Request for Additional Information No. 243 (2991), Revision 0

U. S. EPR Standard Design Certification

SRP Section: 10.02 - Turbine Generator

Question 10.02-6:**A. Follow Up RAI to EPR RAI 10.2-1**

Figure 10.02-6-1—Overspeed Trip System Schematic

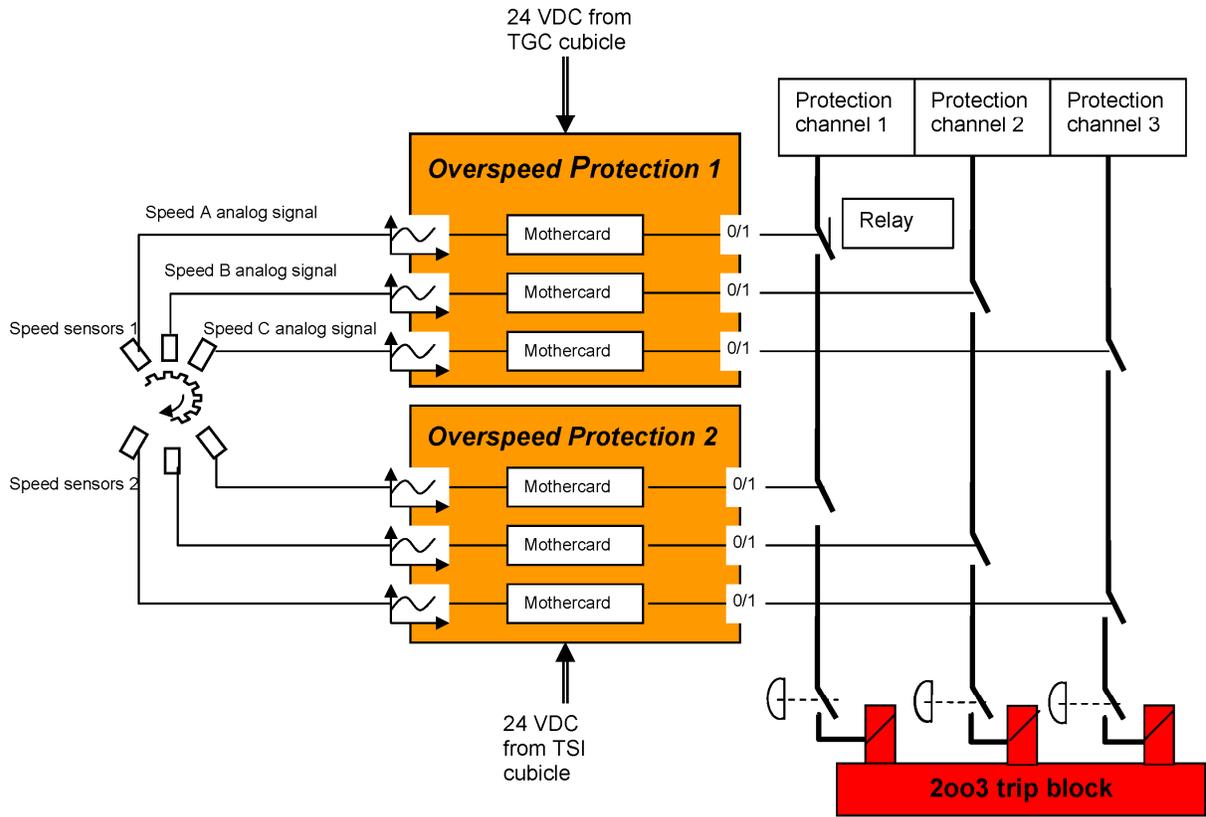
- 1) Identify a COL information item in the FSAR of the U.S. EPR DCD, to enable the COL applicants that use the EPR TG design, for providing the schematics and logic diagrams that were requested in the above U.S. EPR - RAI 10.2-1.
- 2) Address adequately with full justification the meeting of the single failure criteria by the EPR TG design as described in the SRP Section 10.2, Item 1.A of the SRP Acceptance Criteria.

- 1) The response to Part 2) contains schematics for the turbine overspeed trip system.

- 2) The steam turbine is provided with two redundant and diverse electrical overspeed systems. The two electrical overspeed systems meet the single failure criterion; however, they are non-safety related.

The two overspeed protection systems are redundant from the speed probes to the turbine trip relays. Both overspeed protection systems have three independent speed probes and processing modules acting on one of three electronic tripping channels. Each independent electrical overspeed trip system is designed and manufactured by a different vendor. Each vendor directly manufactures their system components (e.g., motherboards, sensors) and develops the software to transform the analog speed sensor signal into a digital signal. There are no common components or process inputs between the two systems. One overspeed protection system is installed in the turbine supervisory instrumentation cubicle and the other overspeed protection system is installed in the turbine governing control cubicle. The cubicles provide separate power supply to each electronic overspeed protection system. Figure 10.02-6-1 shows the separate source of power supply to each system and how the sensors are treated by independent motherboards. This provides sufficient diversity and defense-in-depth for the overspeed protection systems.

The three independent electronic channels energize three fail-safe solenoid valves (trip by loss of power). Each solenoid valve acts on two hydraulic relays of the trip block in order to perform the hydraulic two-out-of-three trip voting. The turbine trips when at least two solenoid valves are de-energized.
